Access Compliance Report

Public Rights-of-Way

Intersection ID: 10861	Main Street: STATESVILLE_AV	Cross Street: DALTON_AV	Location: NE
ADA ID: F5A261F3ACEE	Ramp Type: PerpDiag	Initial Pass/Fail: Fail	Overall Compliance: No
		Severity Score: 10

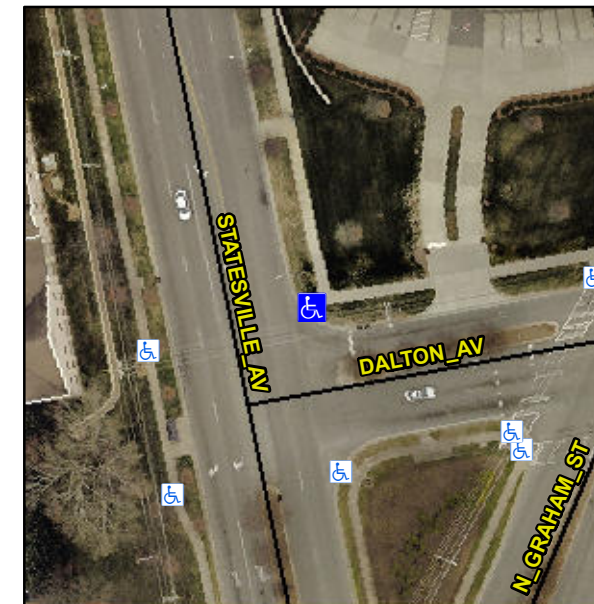
Not Found, R304.5.1, R304.5.3

Compliance	Description	Data	Compliance	Description	Data
N/A	Ramp Length (in)	85.5	Yes	Ramp Slope (%)	7.2
No	Ramp Width (in)	47.5	No	Ramp XSlope (%)	2.4
N/A	Flare Type LT	N/A	N/A	Flare Type RT	N/A
N/A	Flare Slope LT (%)	N/A	N/A	Flare Slope RT (%)	N/A
N/A	Flare Traversable LT?	N/A	N/A	Flare Traversable RT?	N/A
N/A	Landing Length (in)	N/A	N/A	DWS Provided?	N/A
N/A	Landing Width (in)	N/A	N/A	DWS Contrast?	N/A
N/A	Landing Slope (%)	N/A	N/A	DWS Length (in)	N/A
N/A	Landing X Slope (%)	N/A	N/A	DWS Full Width?	N/A
N/A	Landing Curb? (Y/N)	N/A	N/A	DWS Offset (in)	N/A
N/A	Shared Landing?	N/A			
N/A	Gutter Ponding?	N/A	N/A	Gutter Slope (%)	N/A
N/A	Gutter Lip Ht (in)	N/A	N/A	Gutter X Slope (%)	N/A
N/A	Painted X Walk1?	No	N/A	Painted X Walk2?	No
	X Walk 1 Direction	To W		X Walk 2 Direction	To S
N/A	X Walk 1 Width (in)	N/A	N/A	X Walk 2 Width (in)	N/A
	X Walk 1 Slope (%)	3.9		X Walk 2 Slope (%)	0.9
	X Walk 1 X Slope (%)	1.6		X Walk 2 X Slope (%)	1.0

Remove & Replace Curb Ramp With Two New Directional Ramps or Equivalent.
